MY02 Monitoring Report

Longhorn Riparian Buffer Mitigation Site

DMS Project No. 100114

**Re: Longhorn – Task 6 MY 2 (DMS Project No. 100114)
Response to Comments**

Project: Longhorn Riparian Buffer Mitigation Site Catalog Unit 03030003 Title: Mitigation Plan	Date: November 2019	Revision Date: 2/26/2020
	Scale: 1"=300'	Job Number: LMG19.249
	Drawn By: GSF	Figure: 8

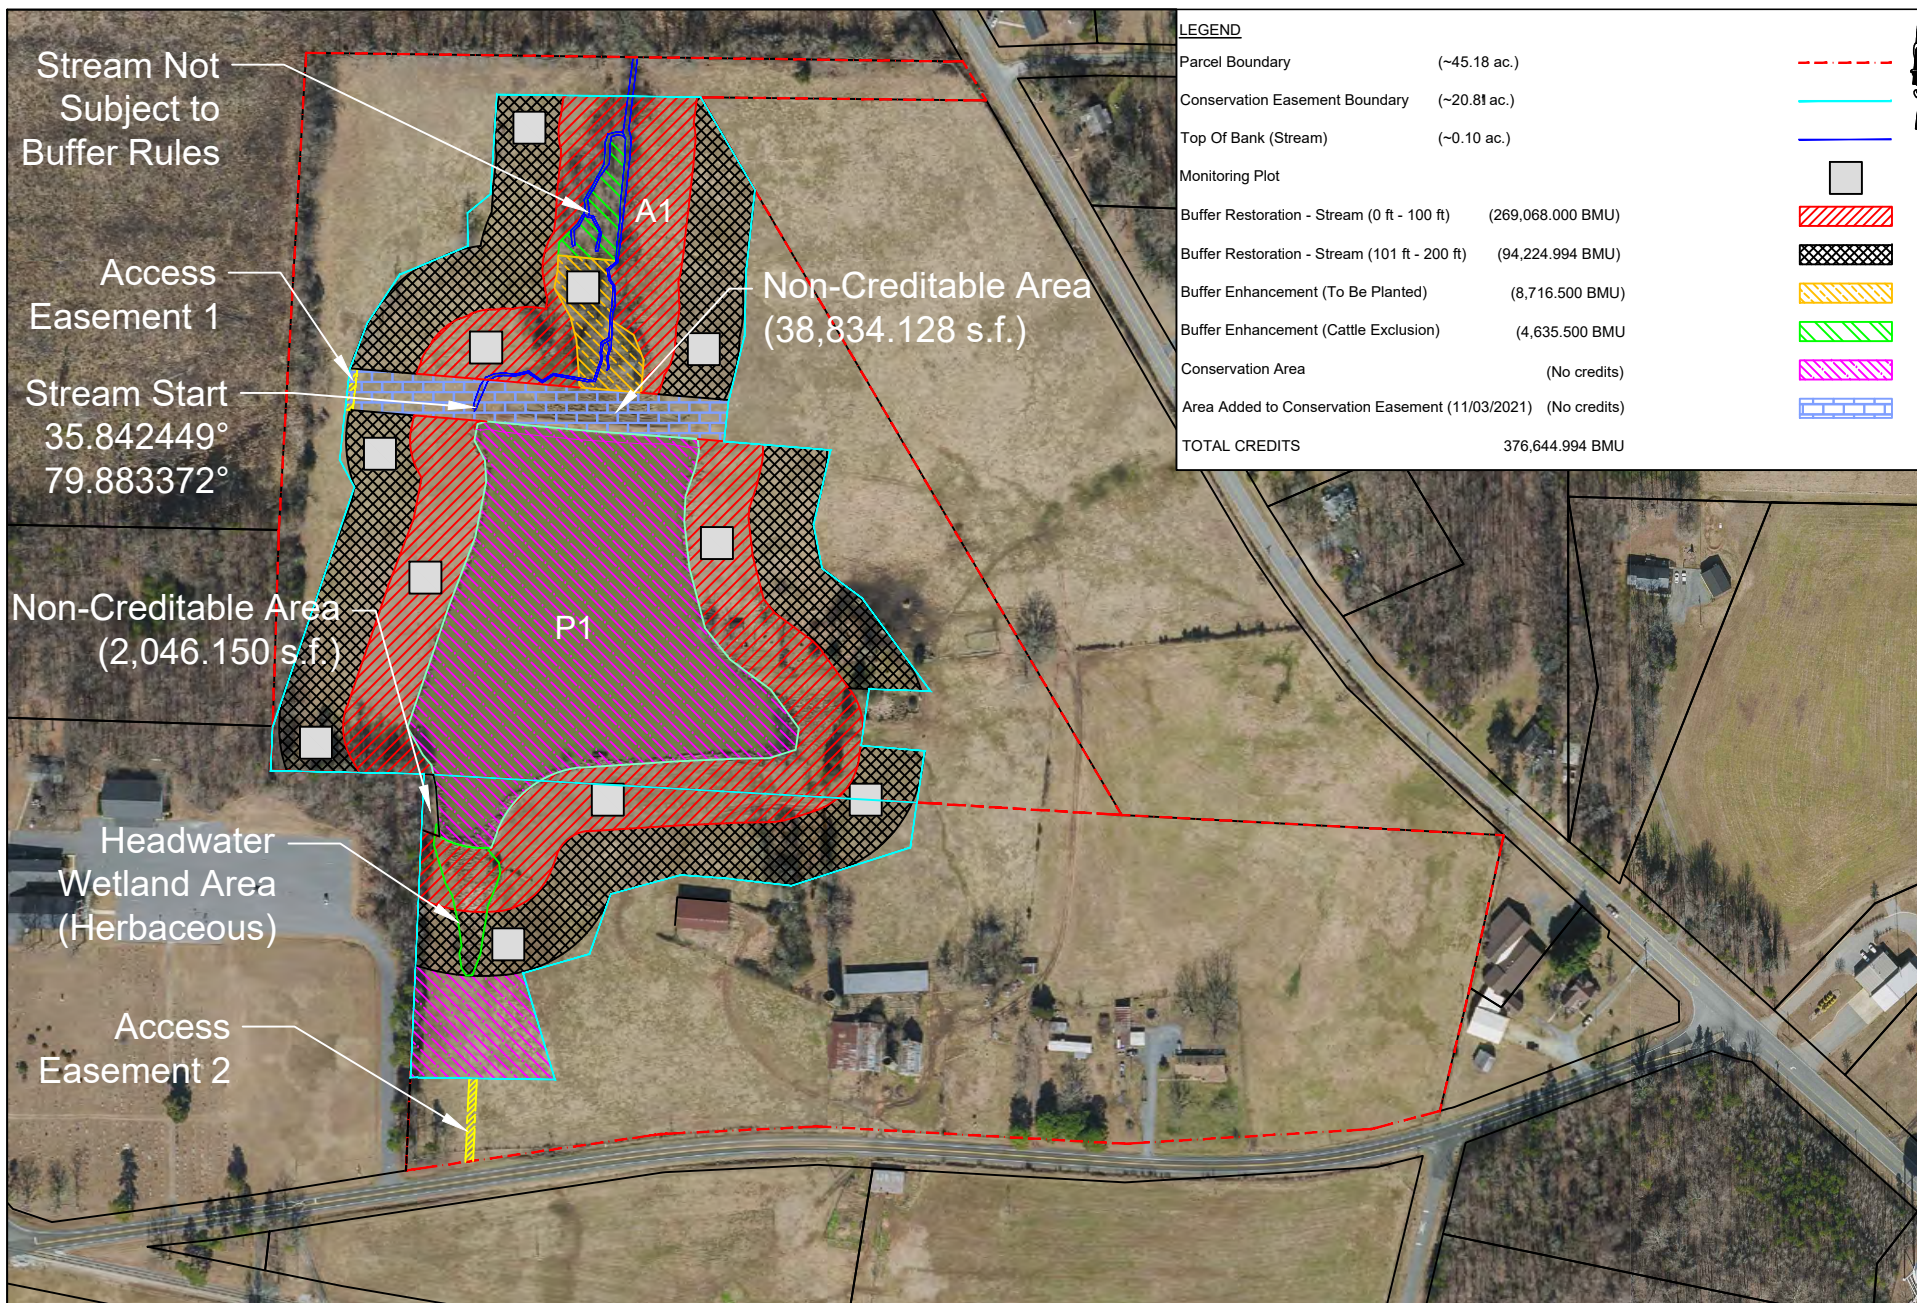
1. Need to include the visual assessment table.
Re: Included within Appendix B.
2. Provide invasives treatment shapefile.
Re: Provided.
3. Also provide .jpg of photos submitted in report.
Re: Included as a digital file.
4. Section 3.2 - second paragraph says planting consisted of planting approximately 538 stems/acre, but 1st paragraph of section 4.3 states 673 stems/acre. Need to clarify.
Re: Section 3.2 second paragraph has been corrected to “673 stems/acre”. Annual monitoring (MY02) was conducted on September 23, 2021 by LMG staff. An average stem density of 435 planted stems per acre was tallied across the monitoring plots (approximately 65% of the recorded baseline (MY0) plot density (673 stems per acre)).
5. Figure 8 - has dam area to be added to CE at later date.
Re: “Area Added to Conservation Easement (11/03/2021)” as noted in legend on Figure 8.
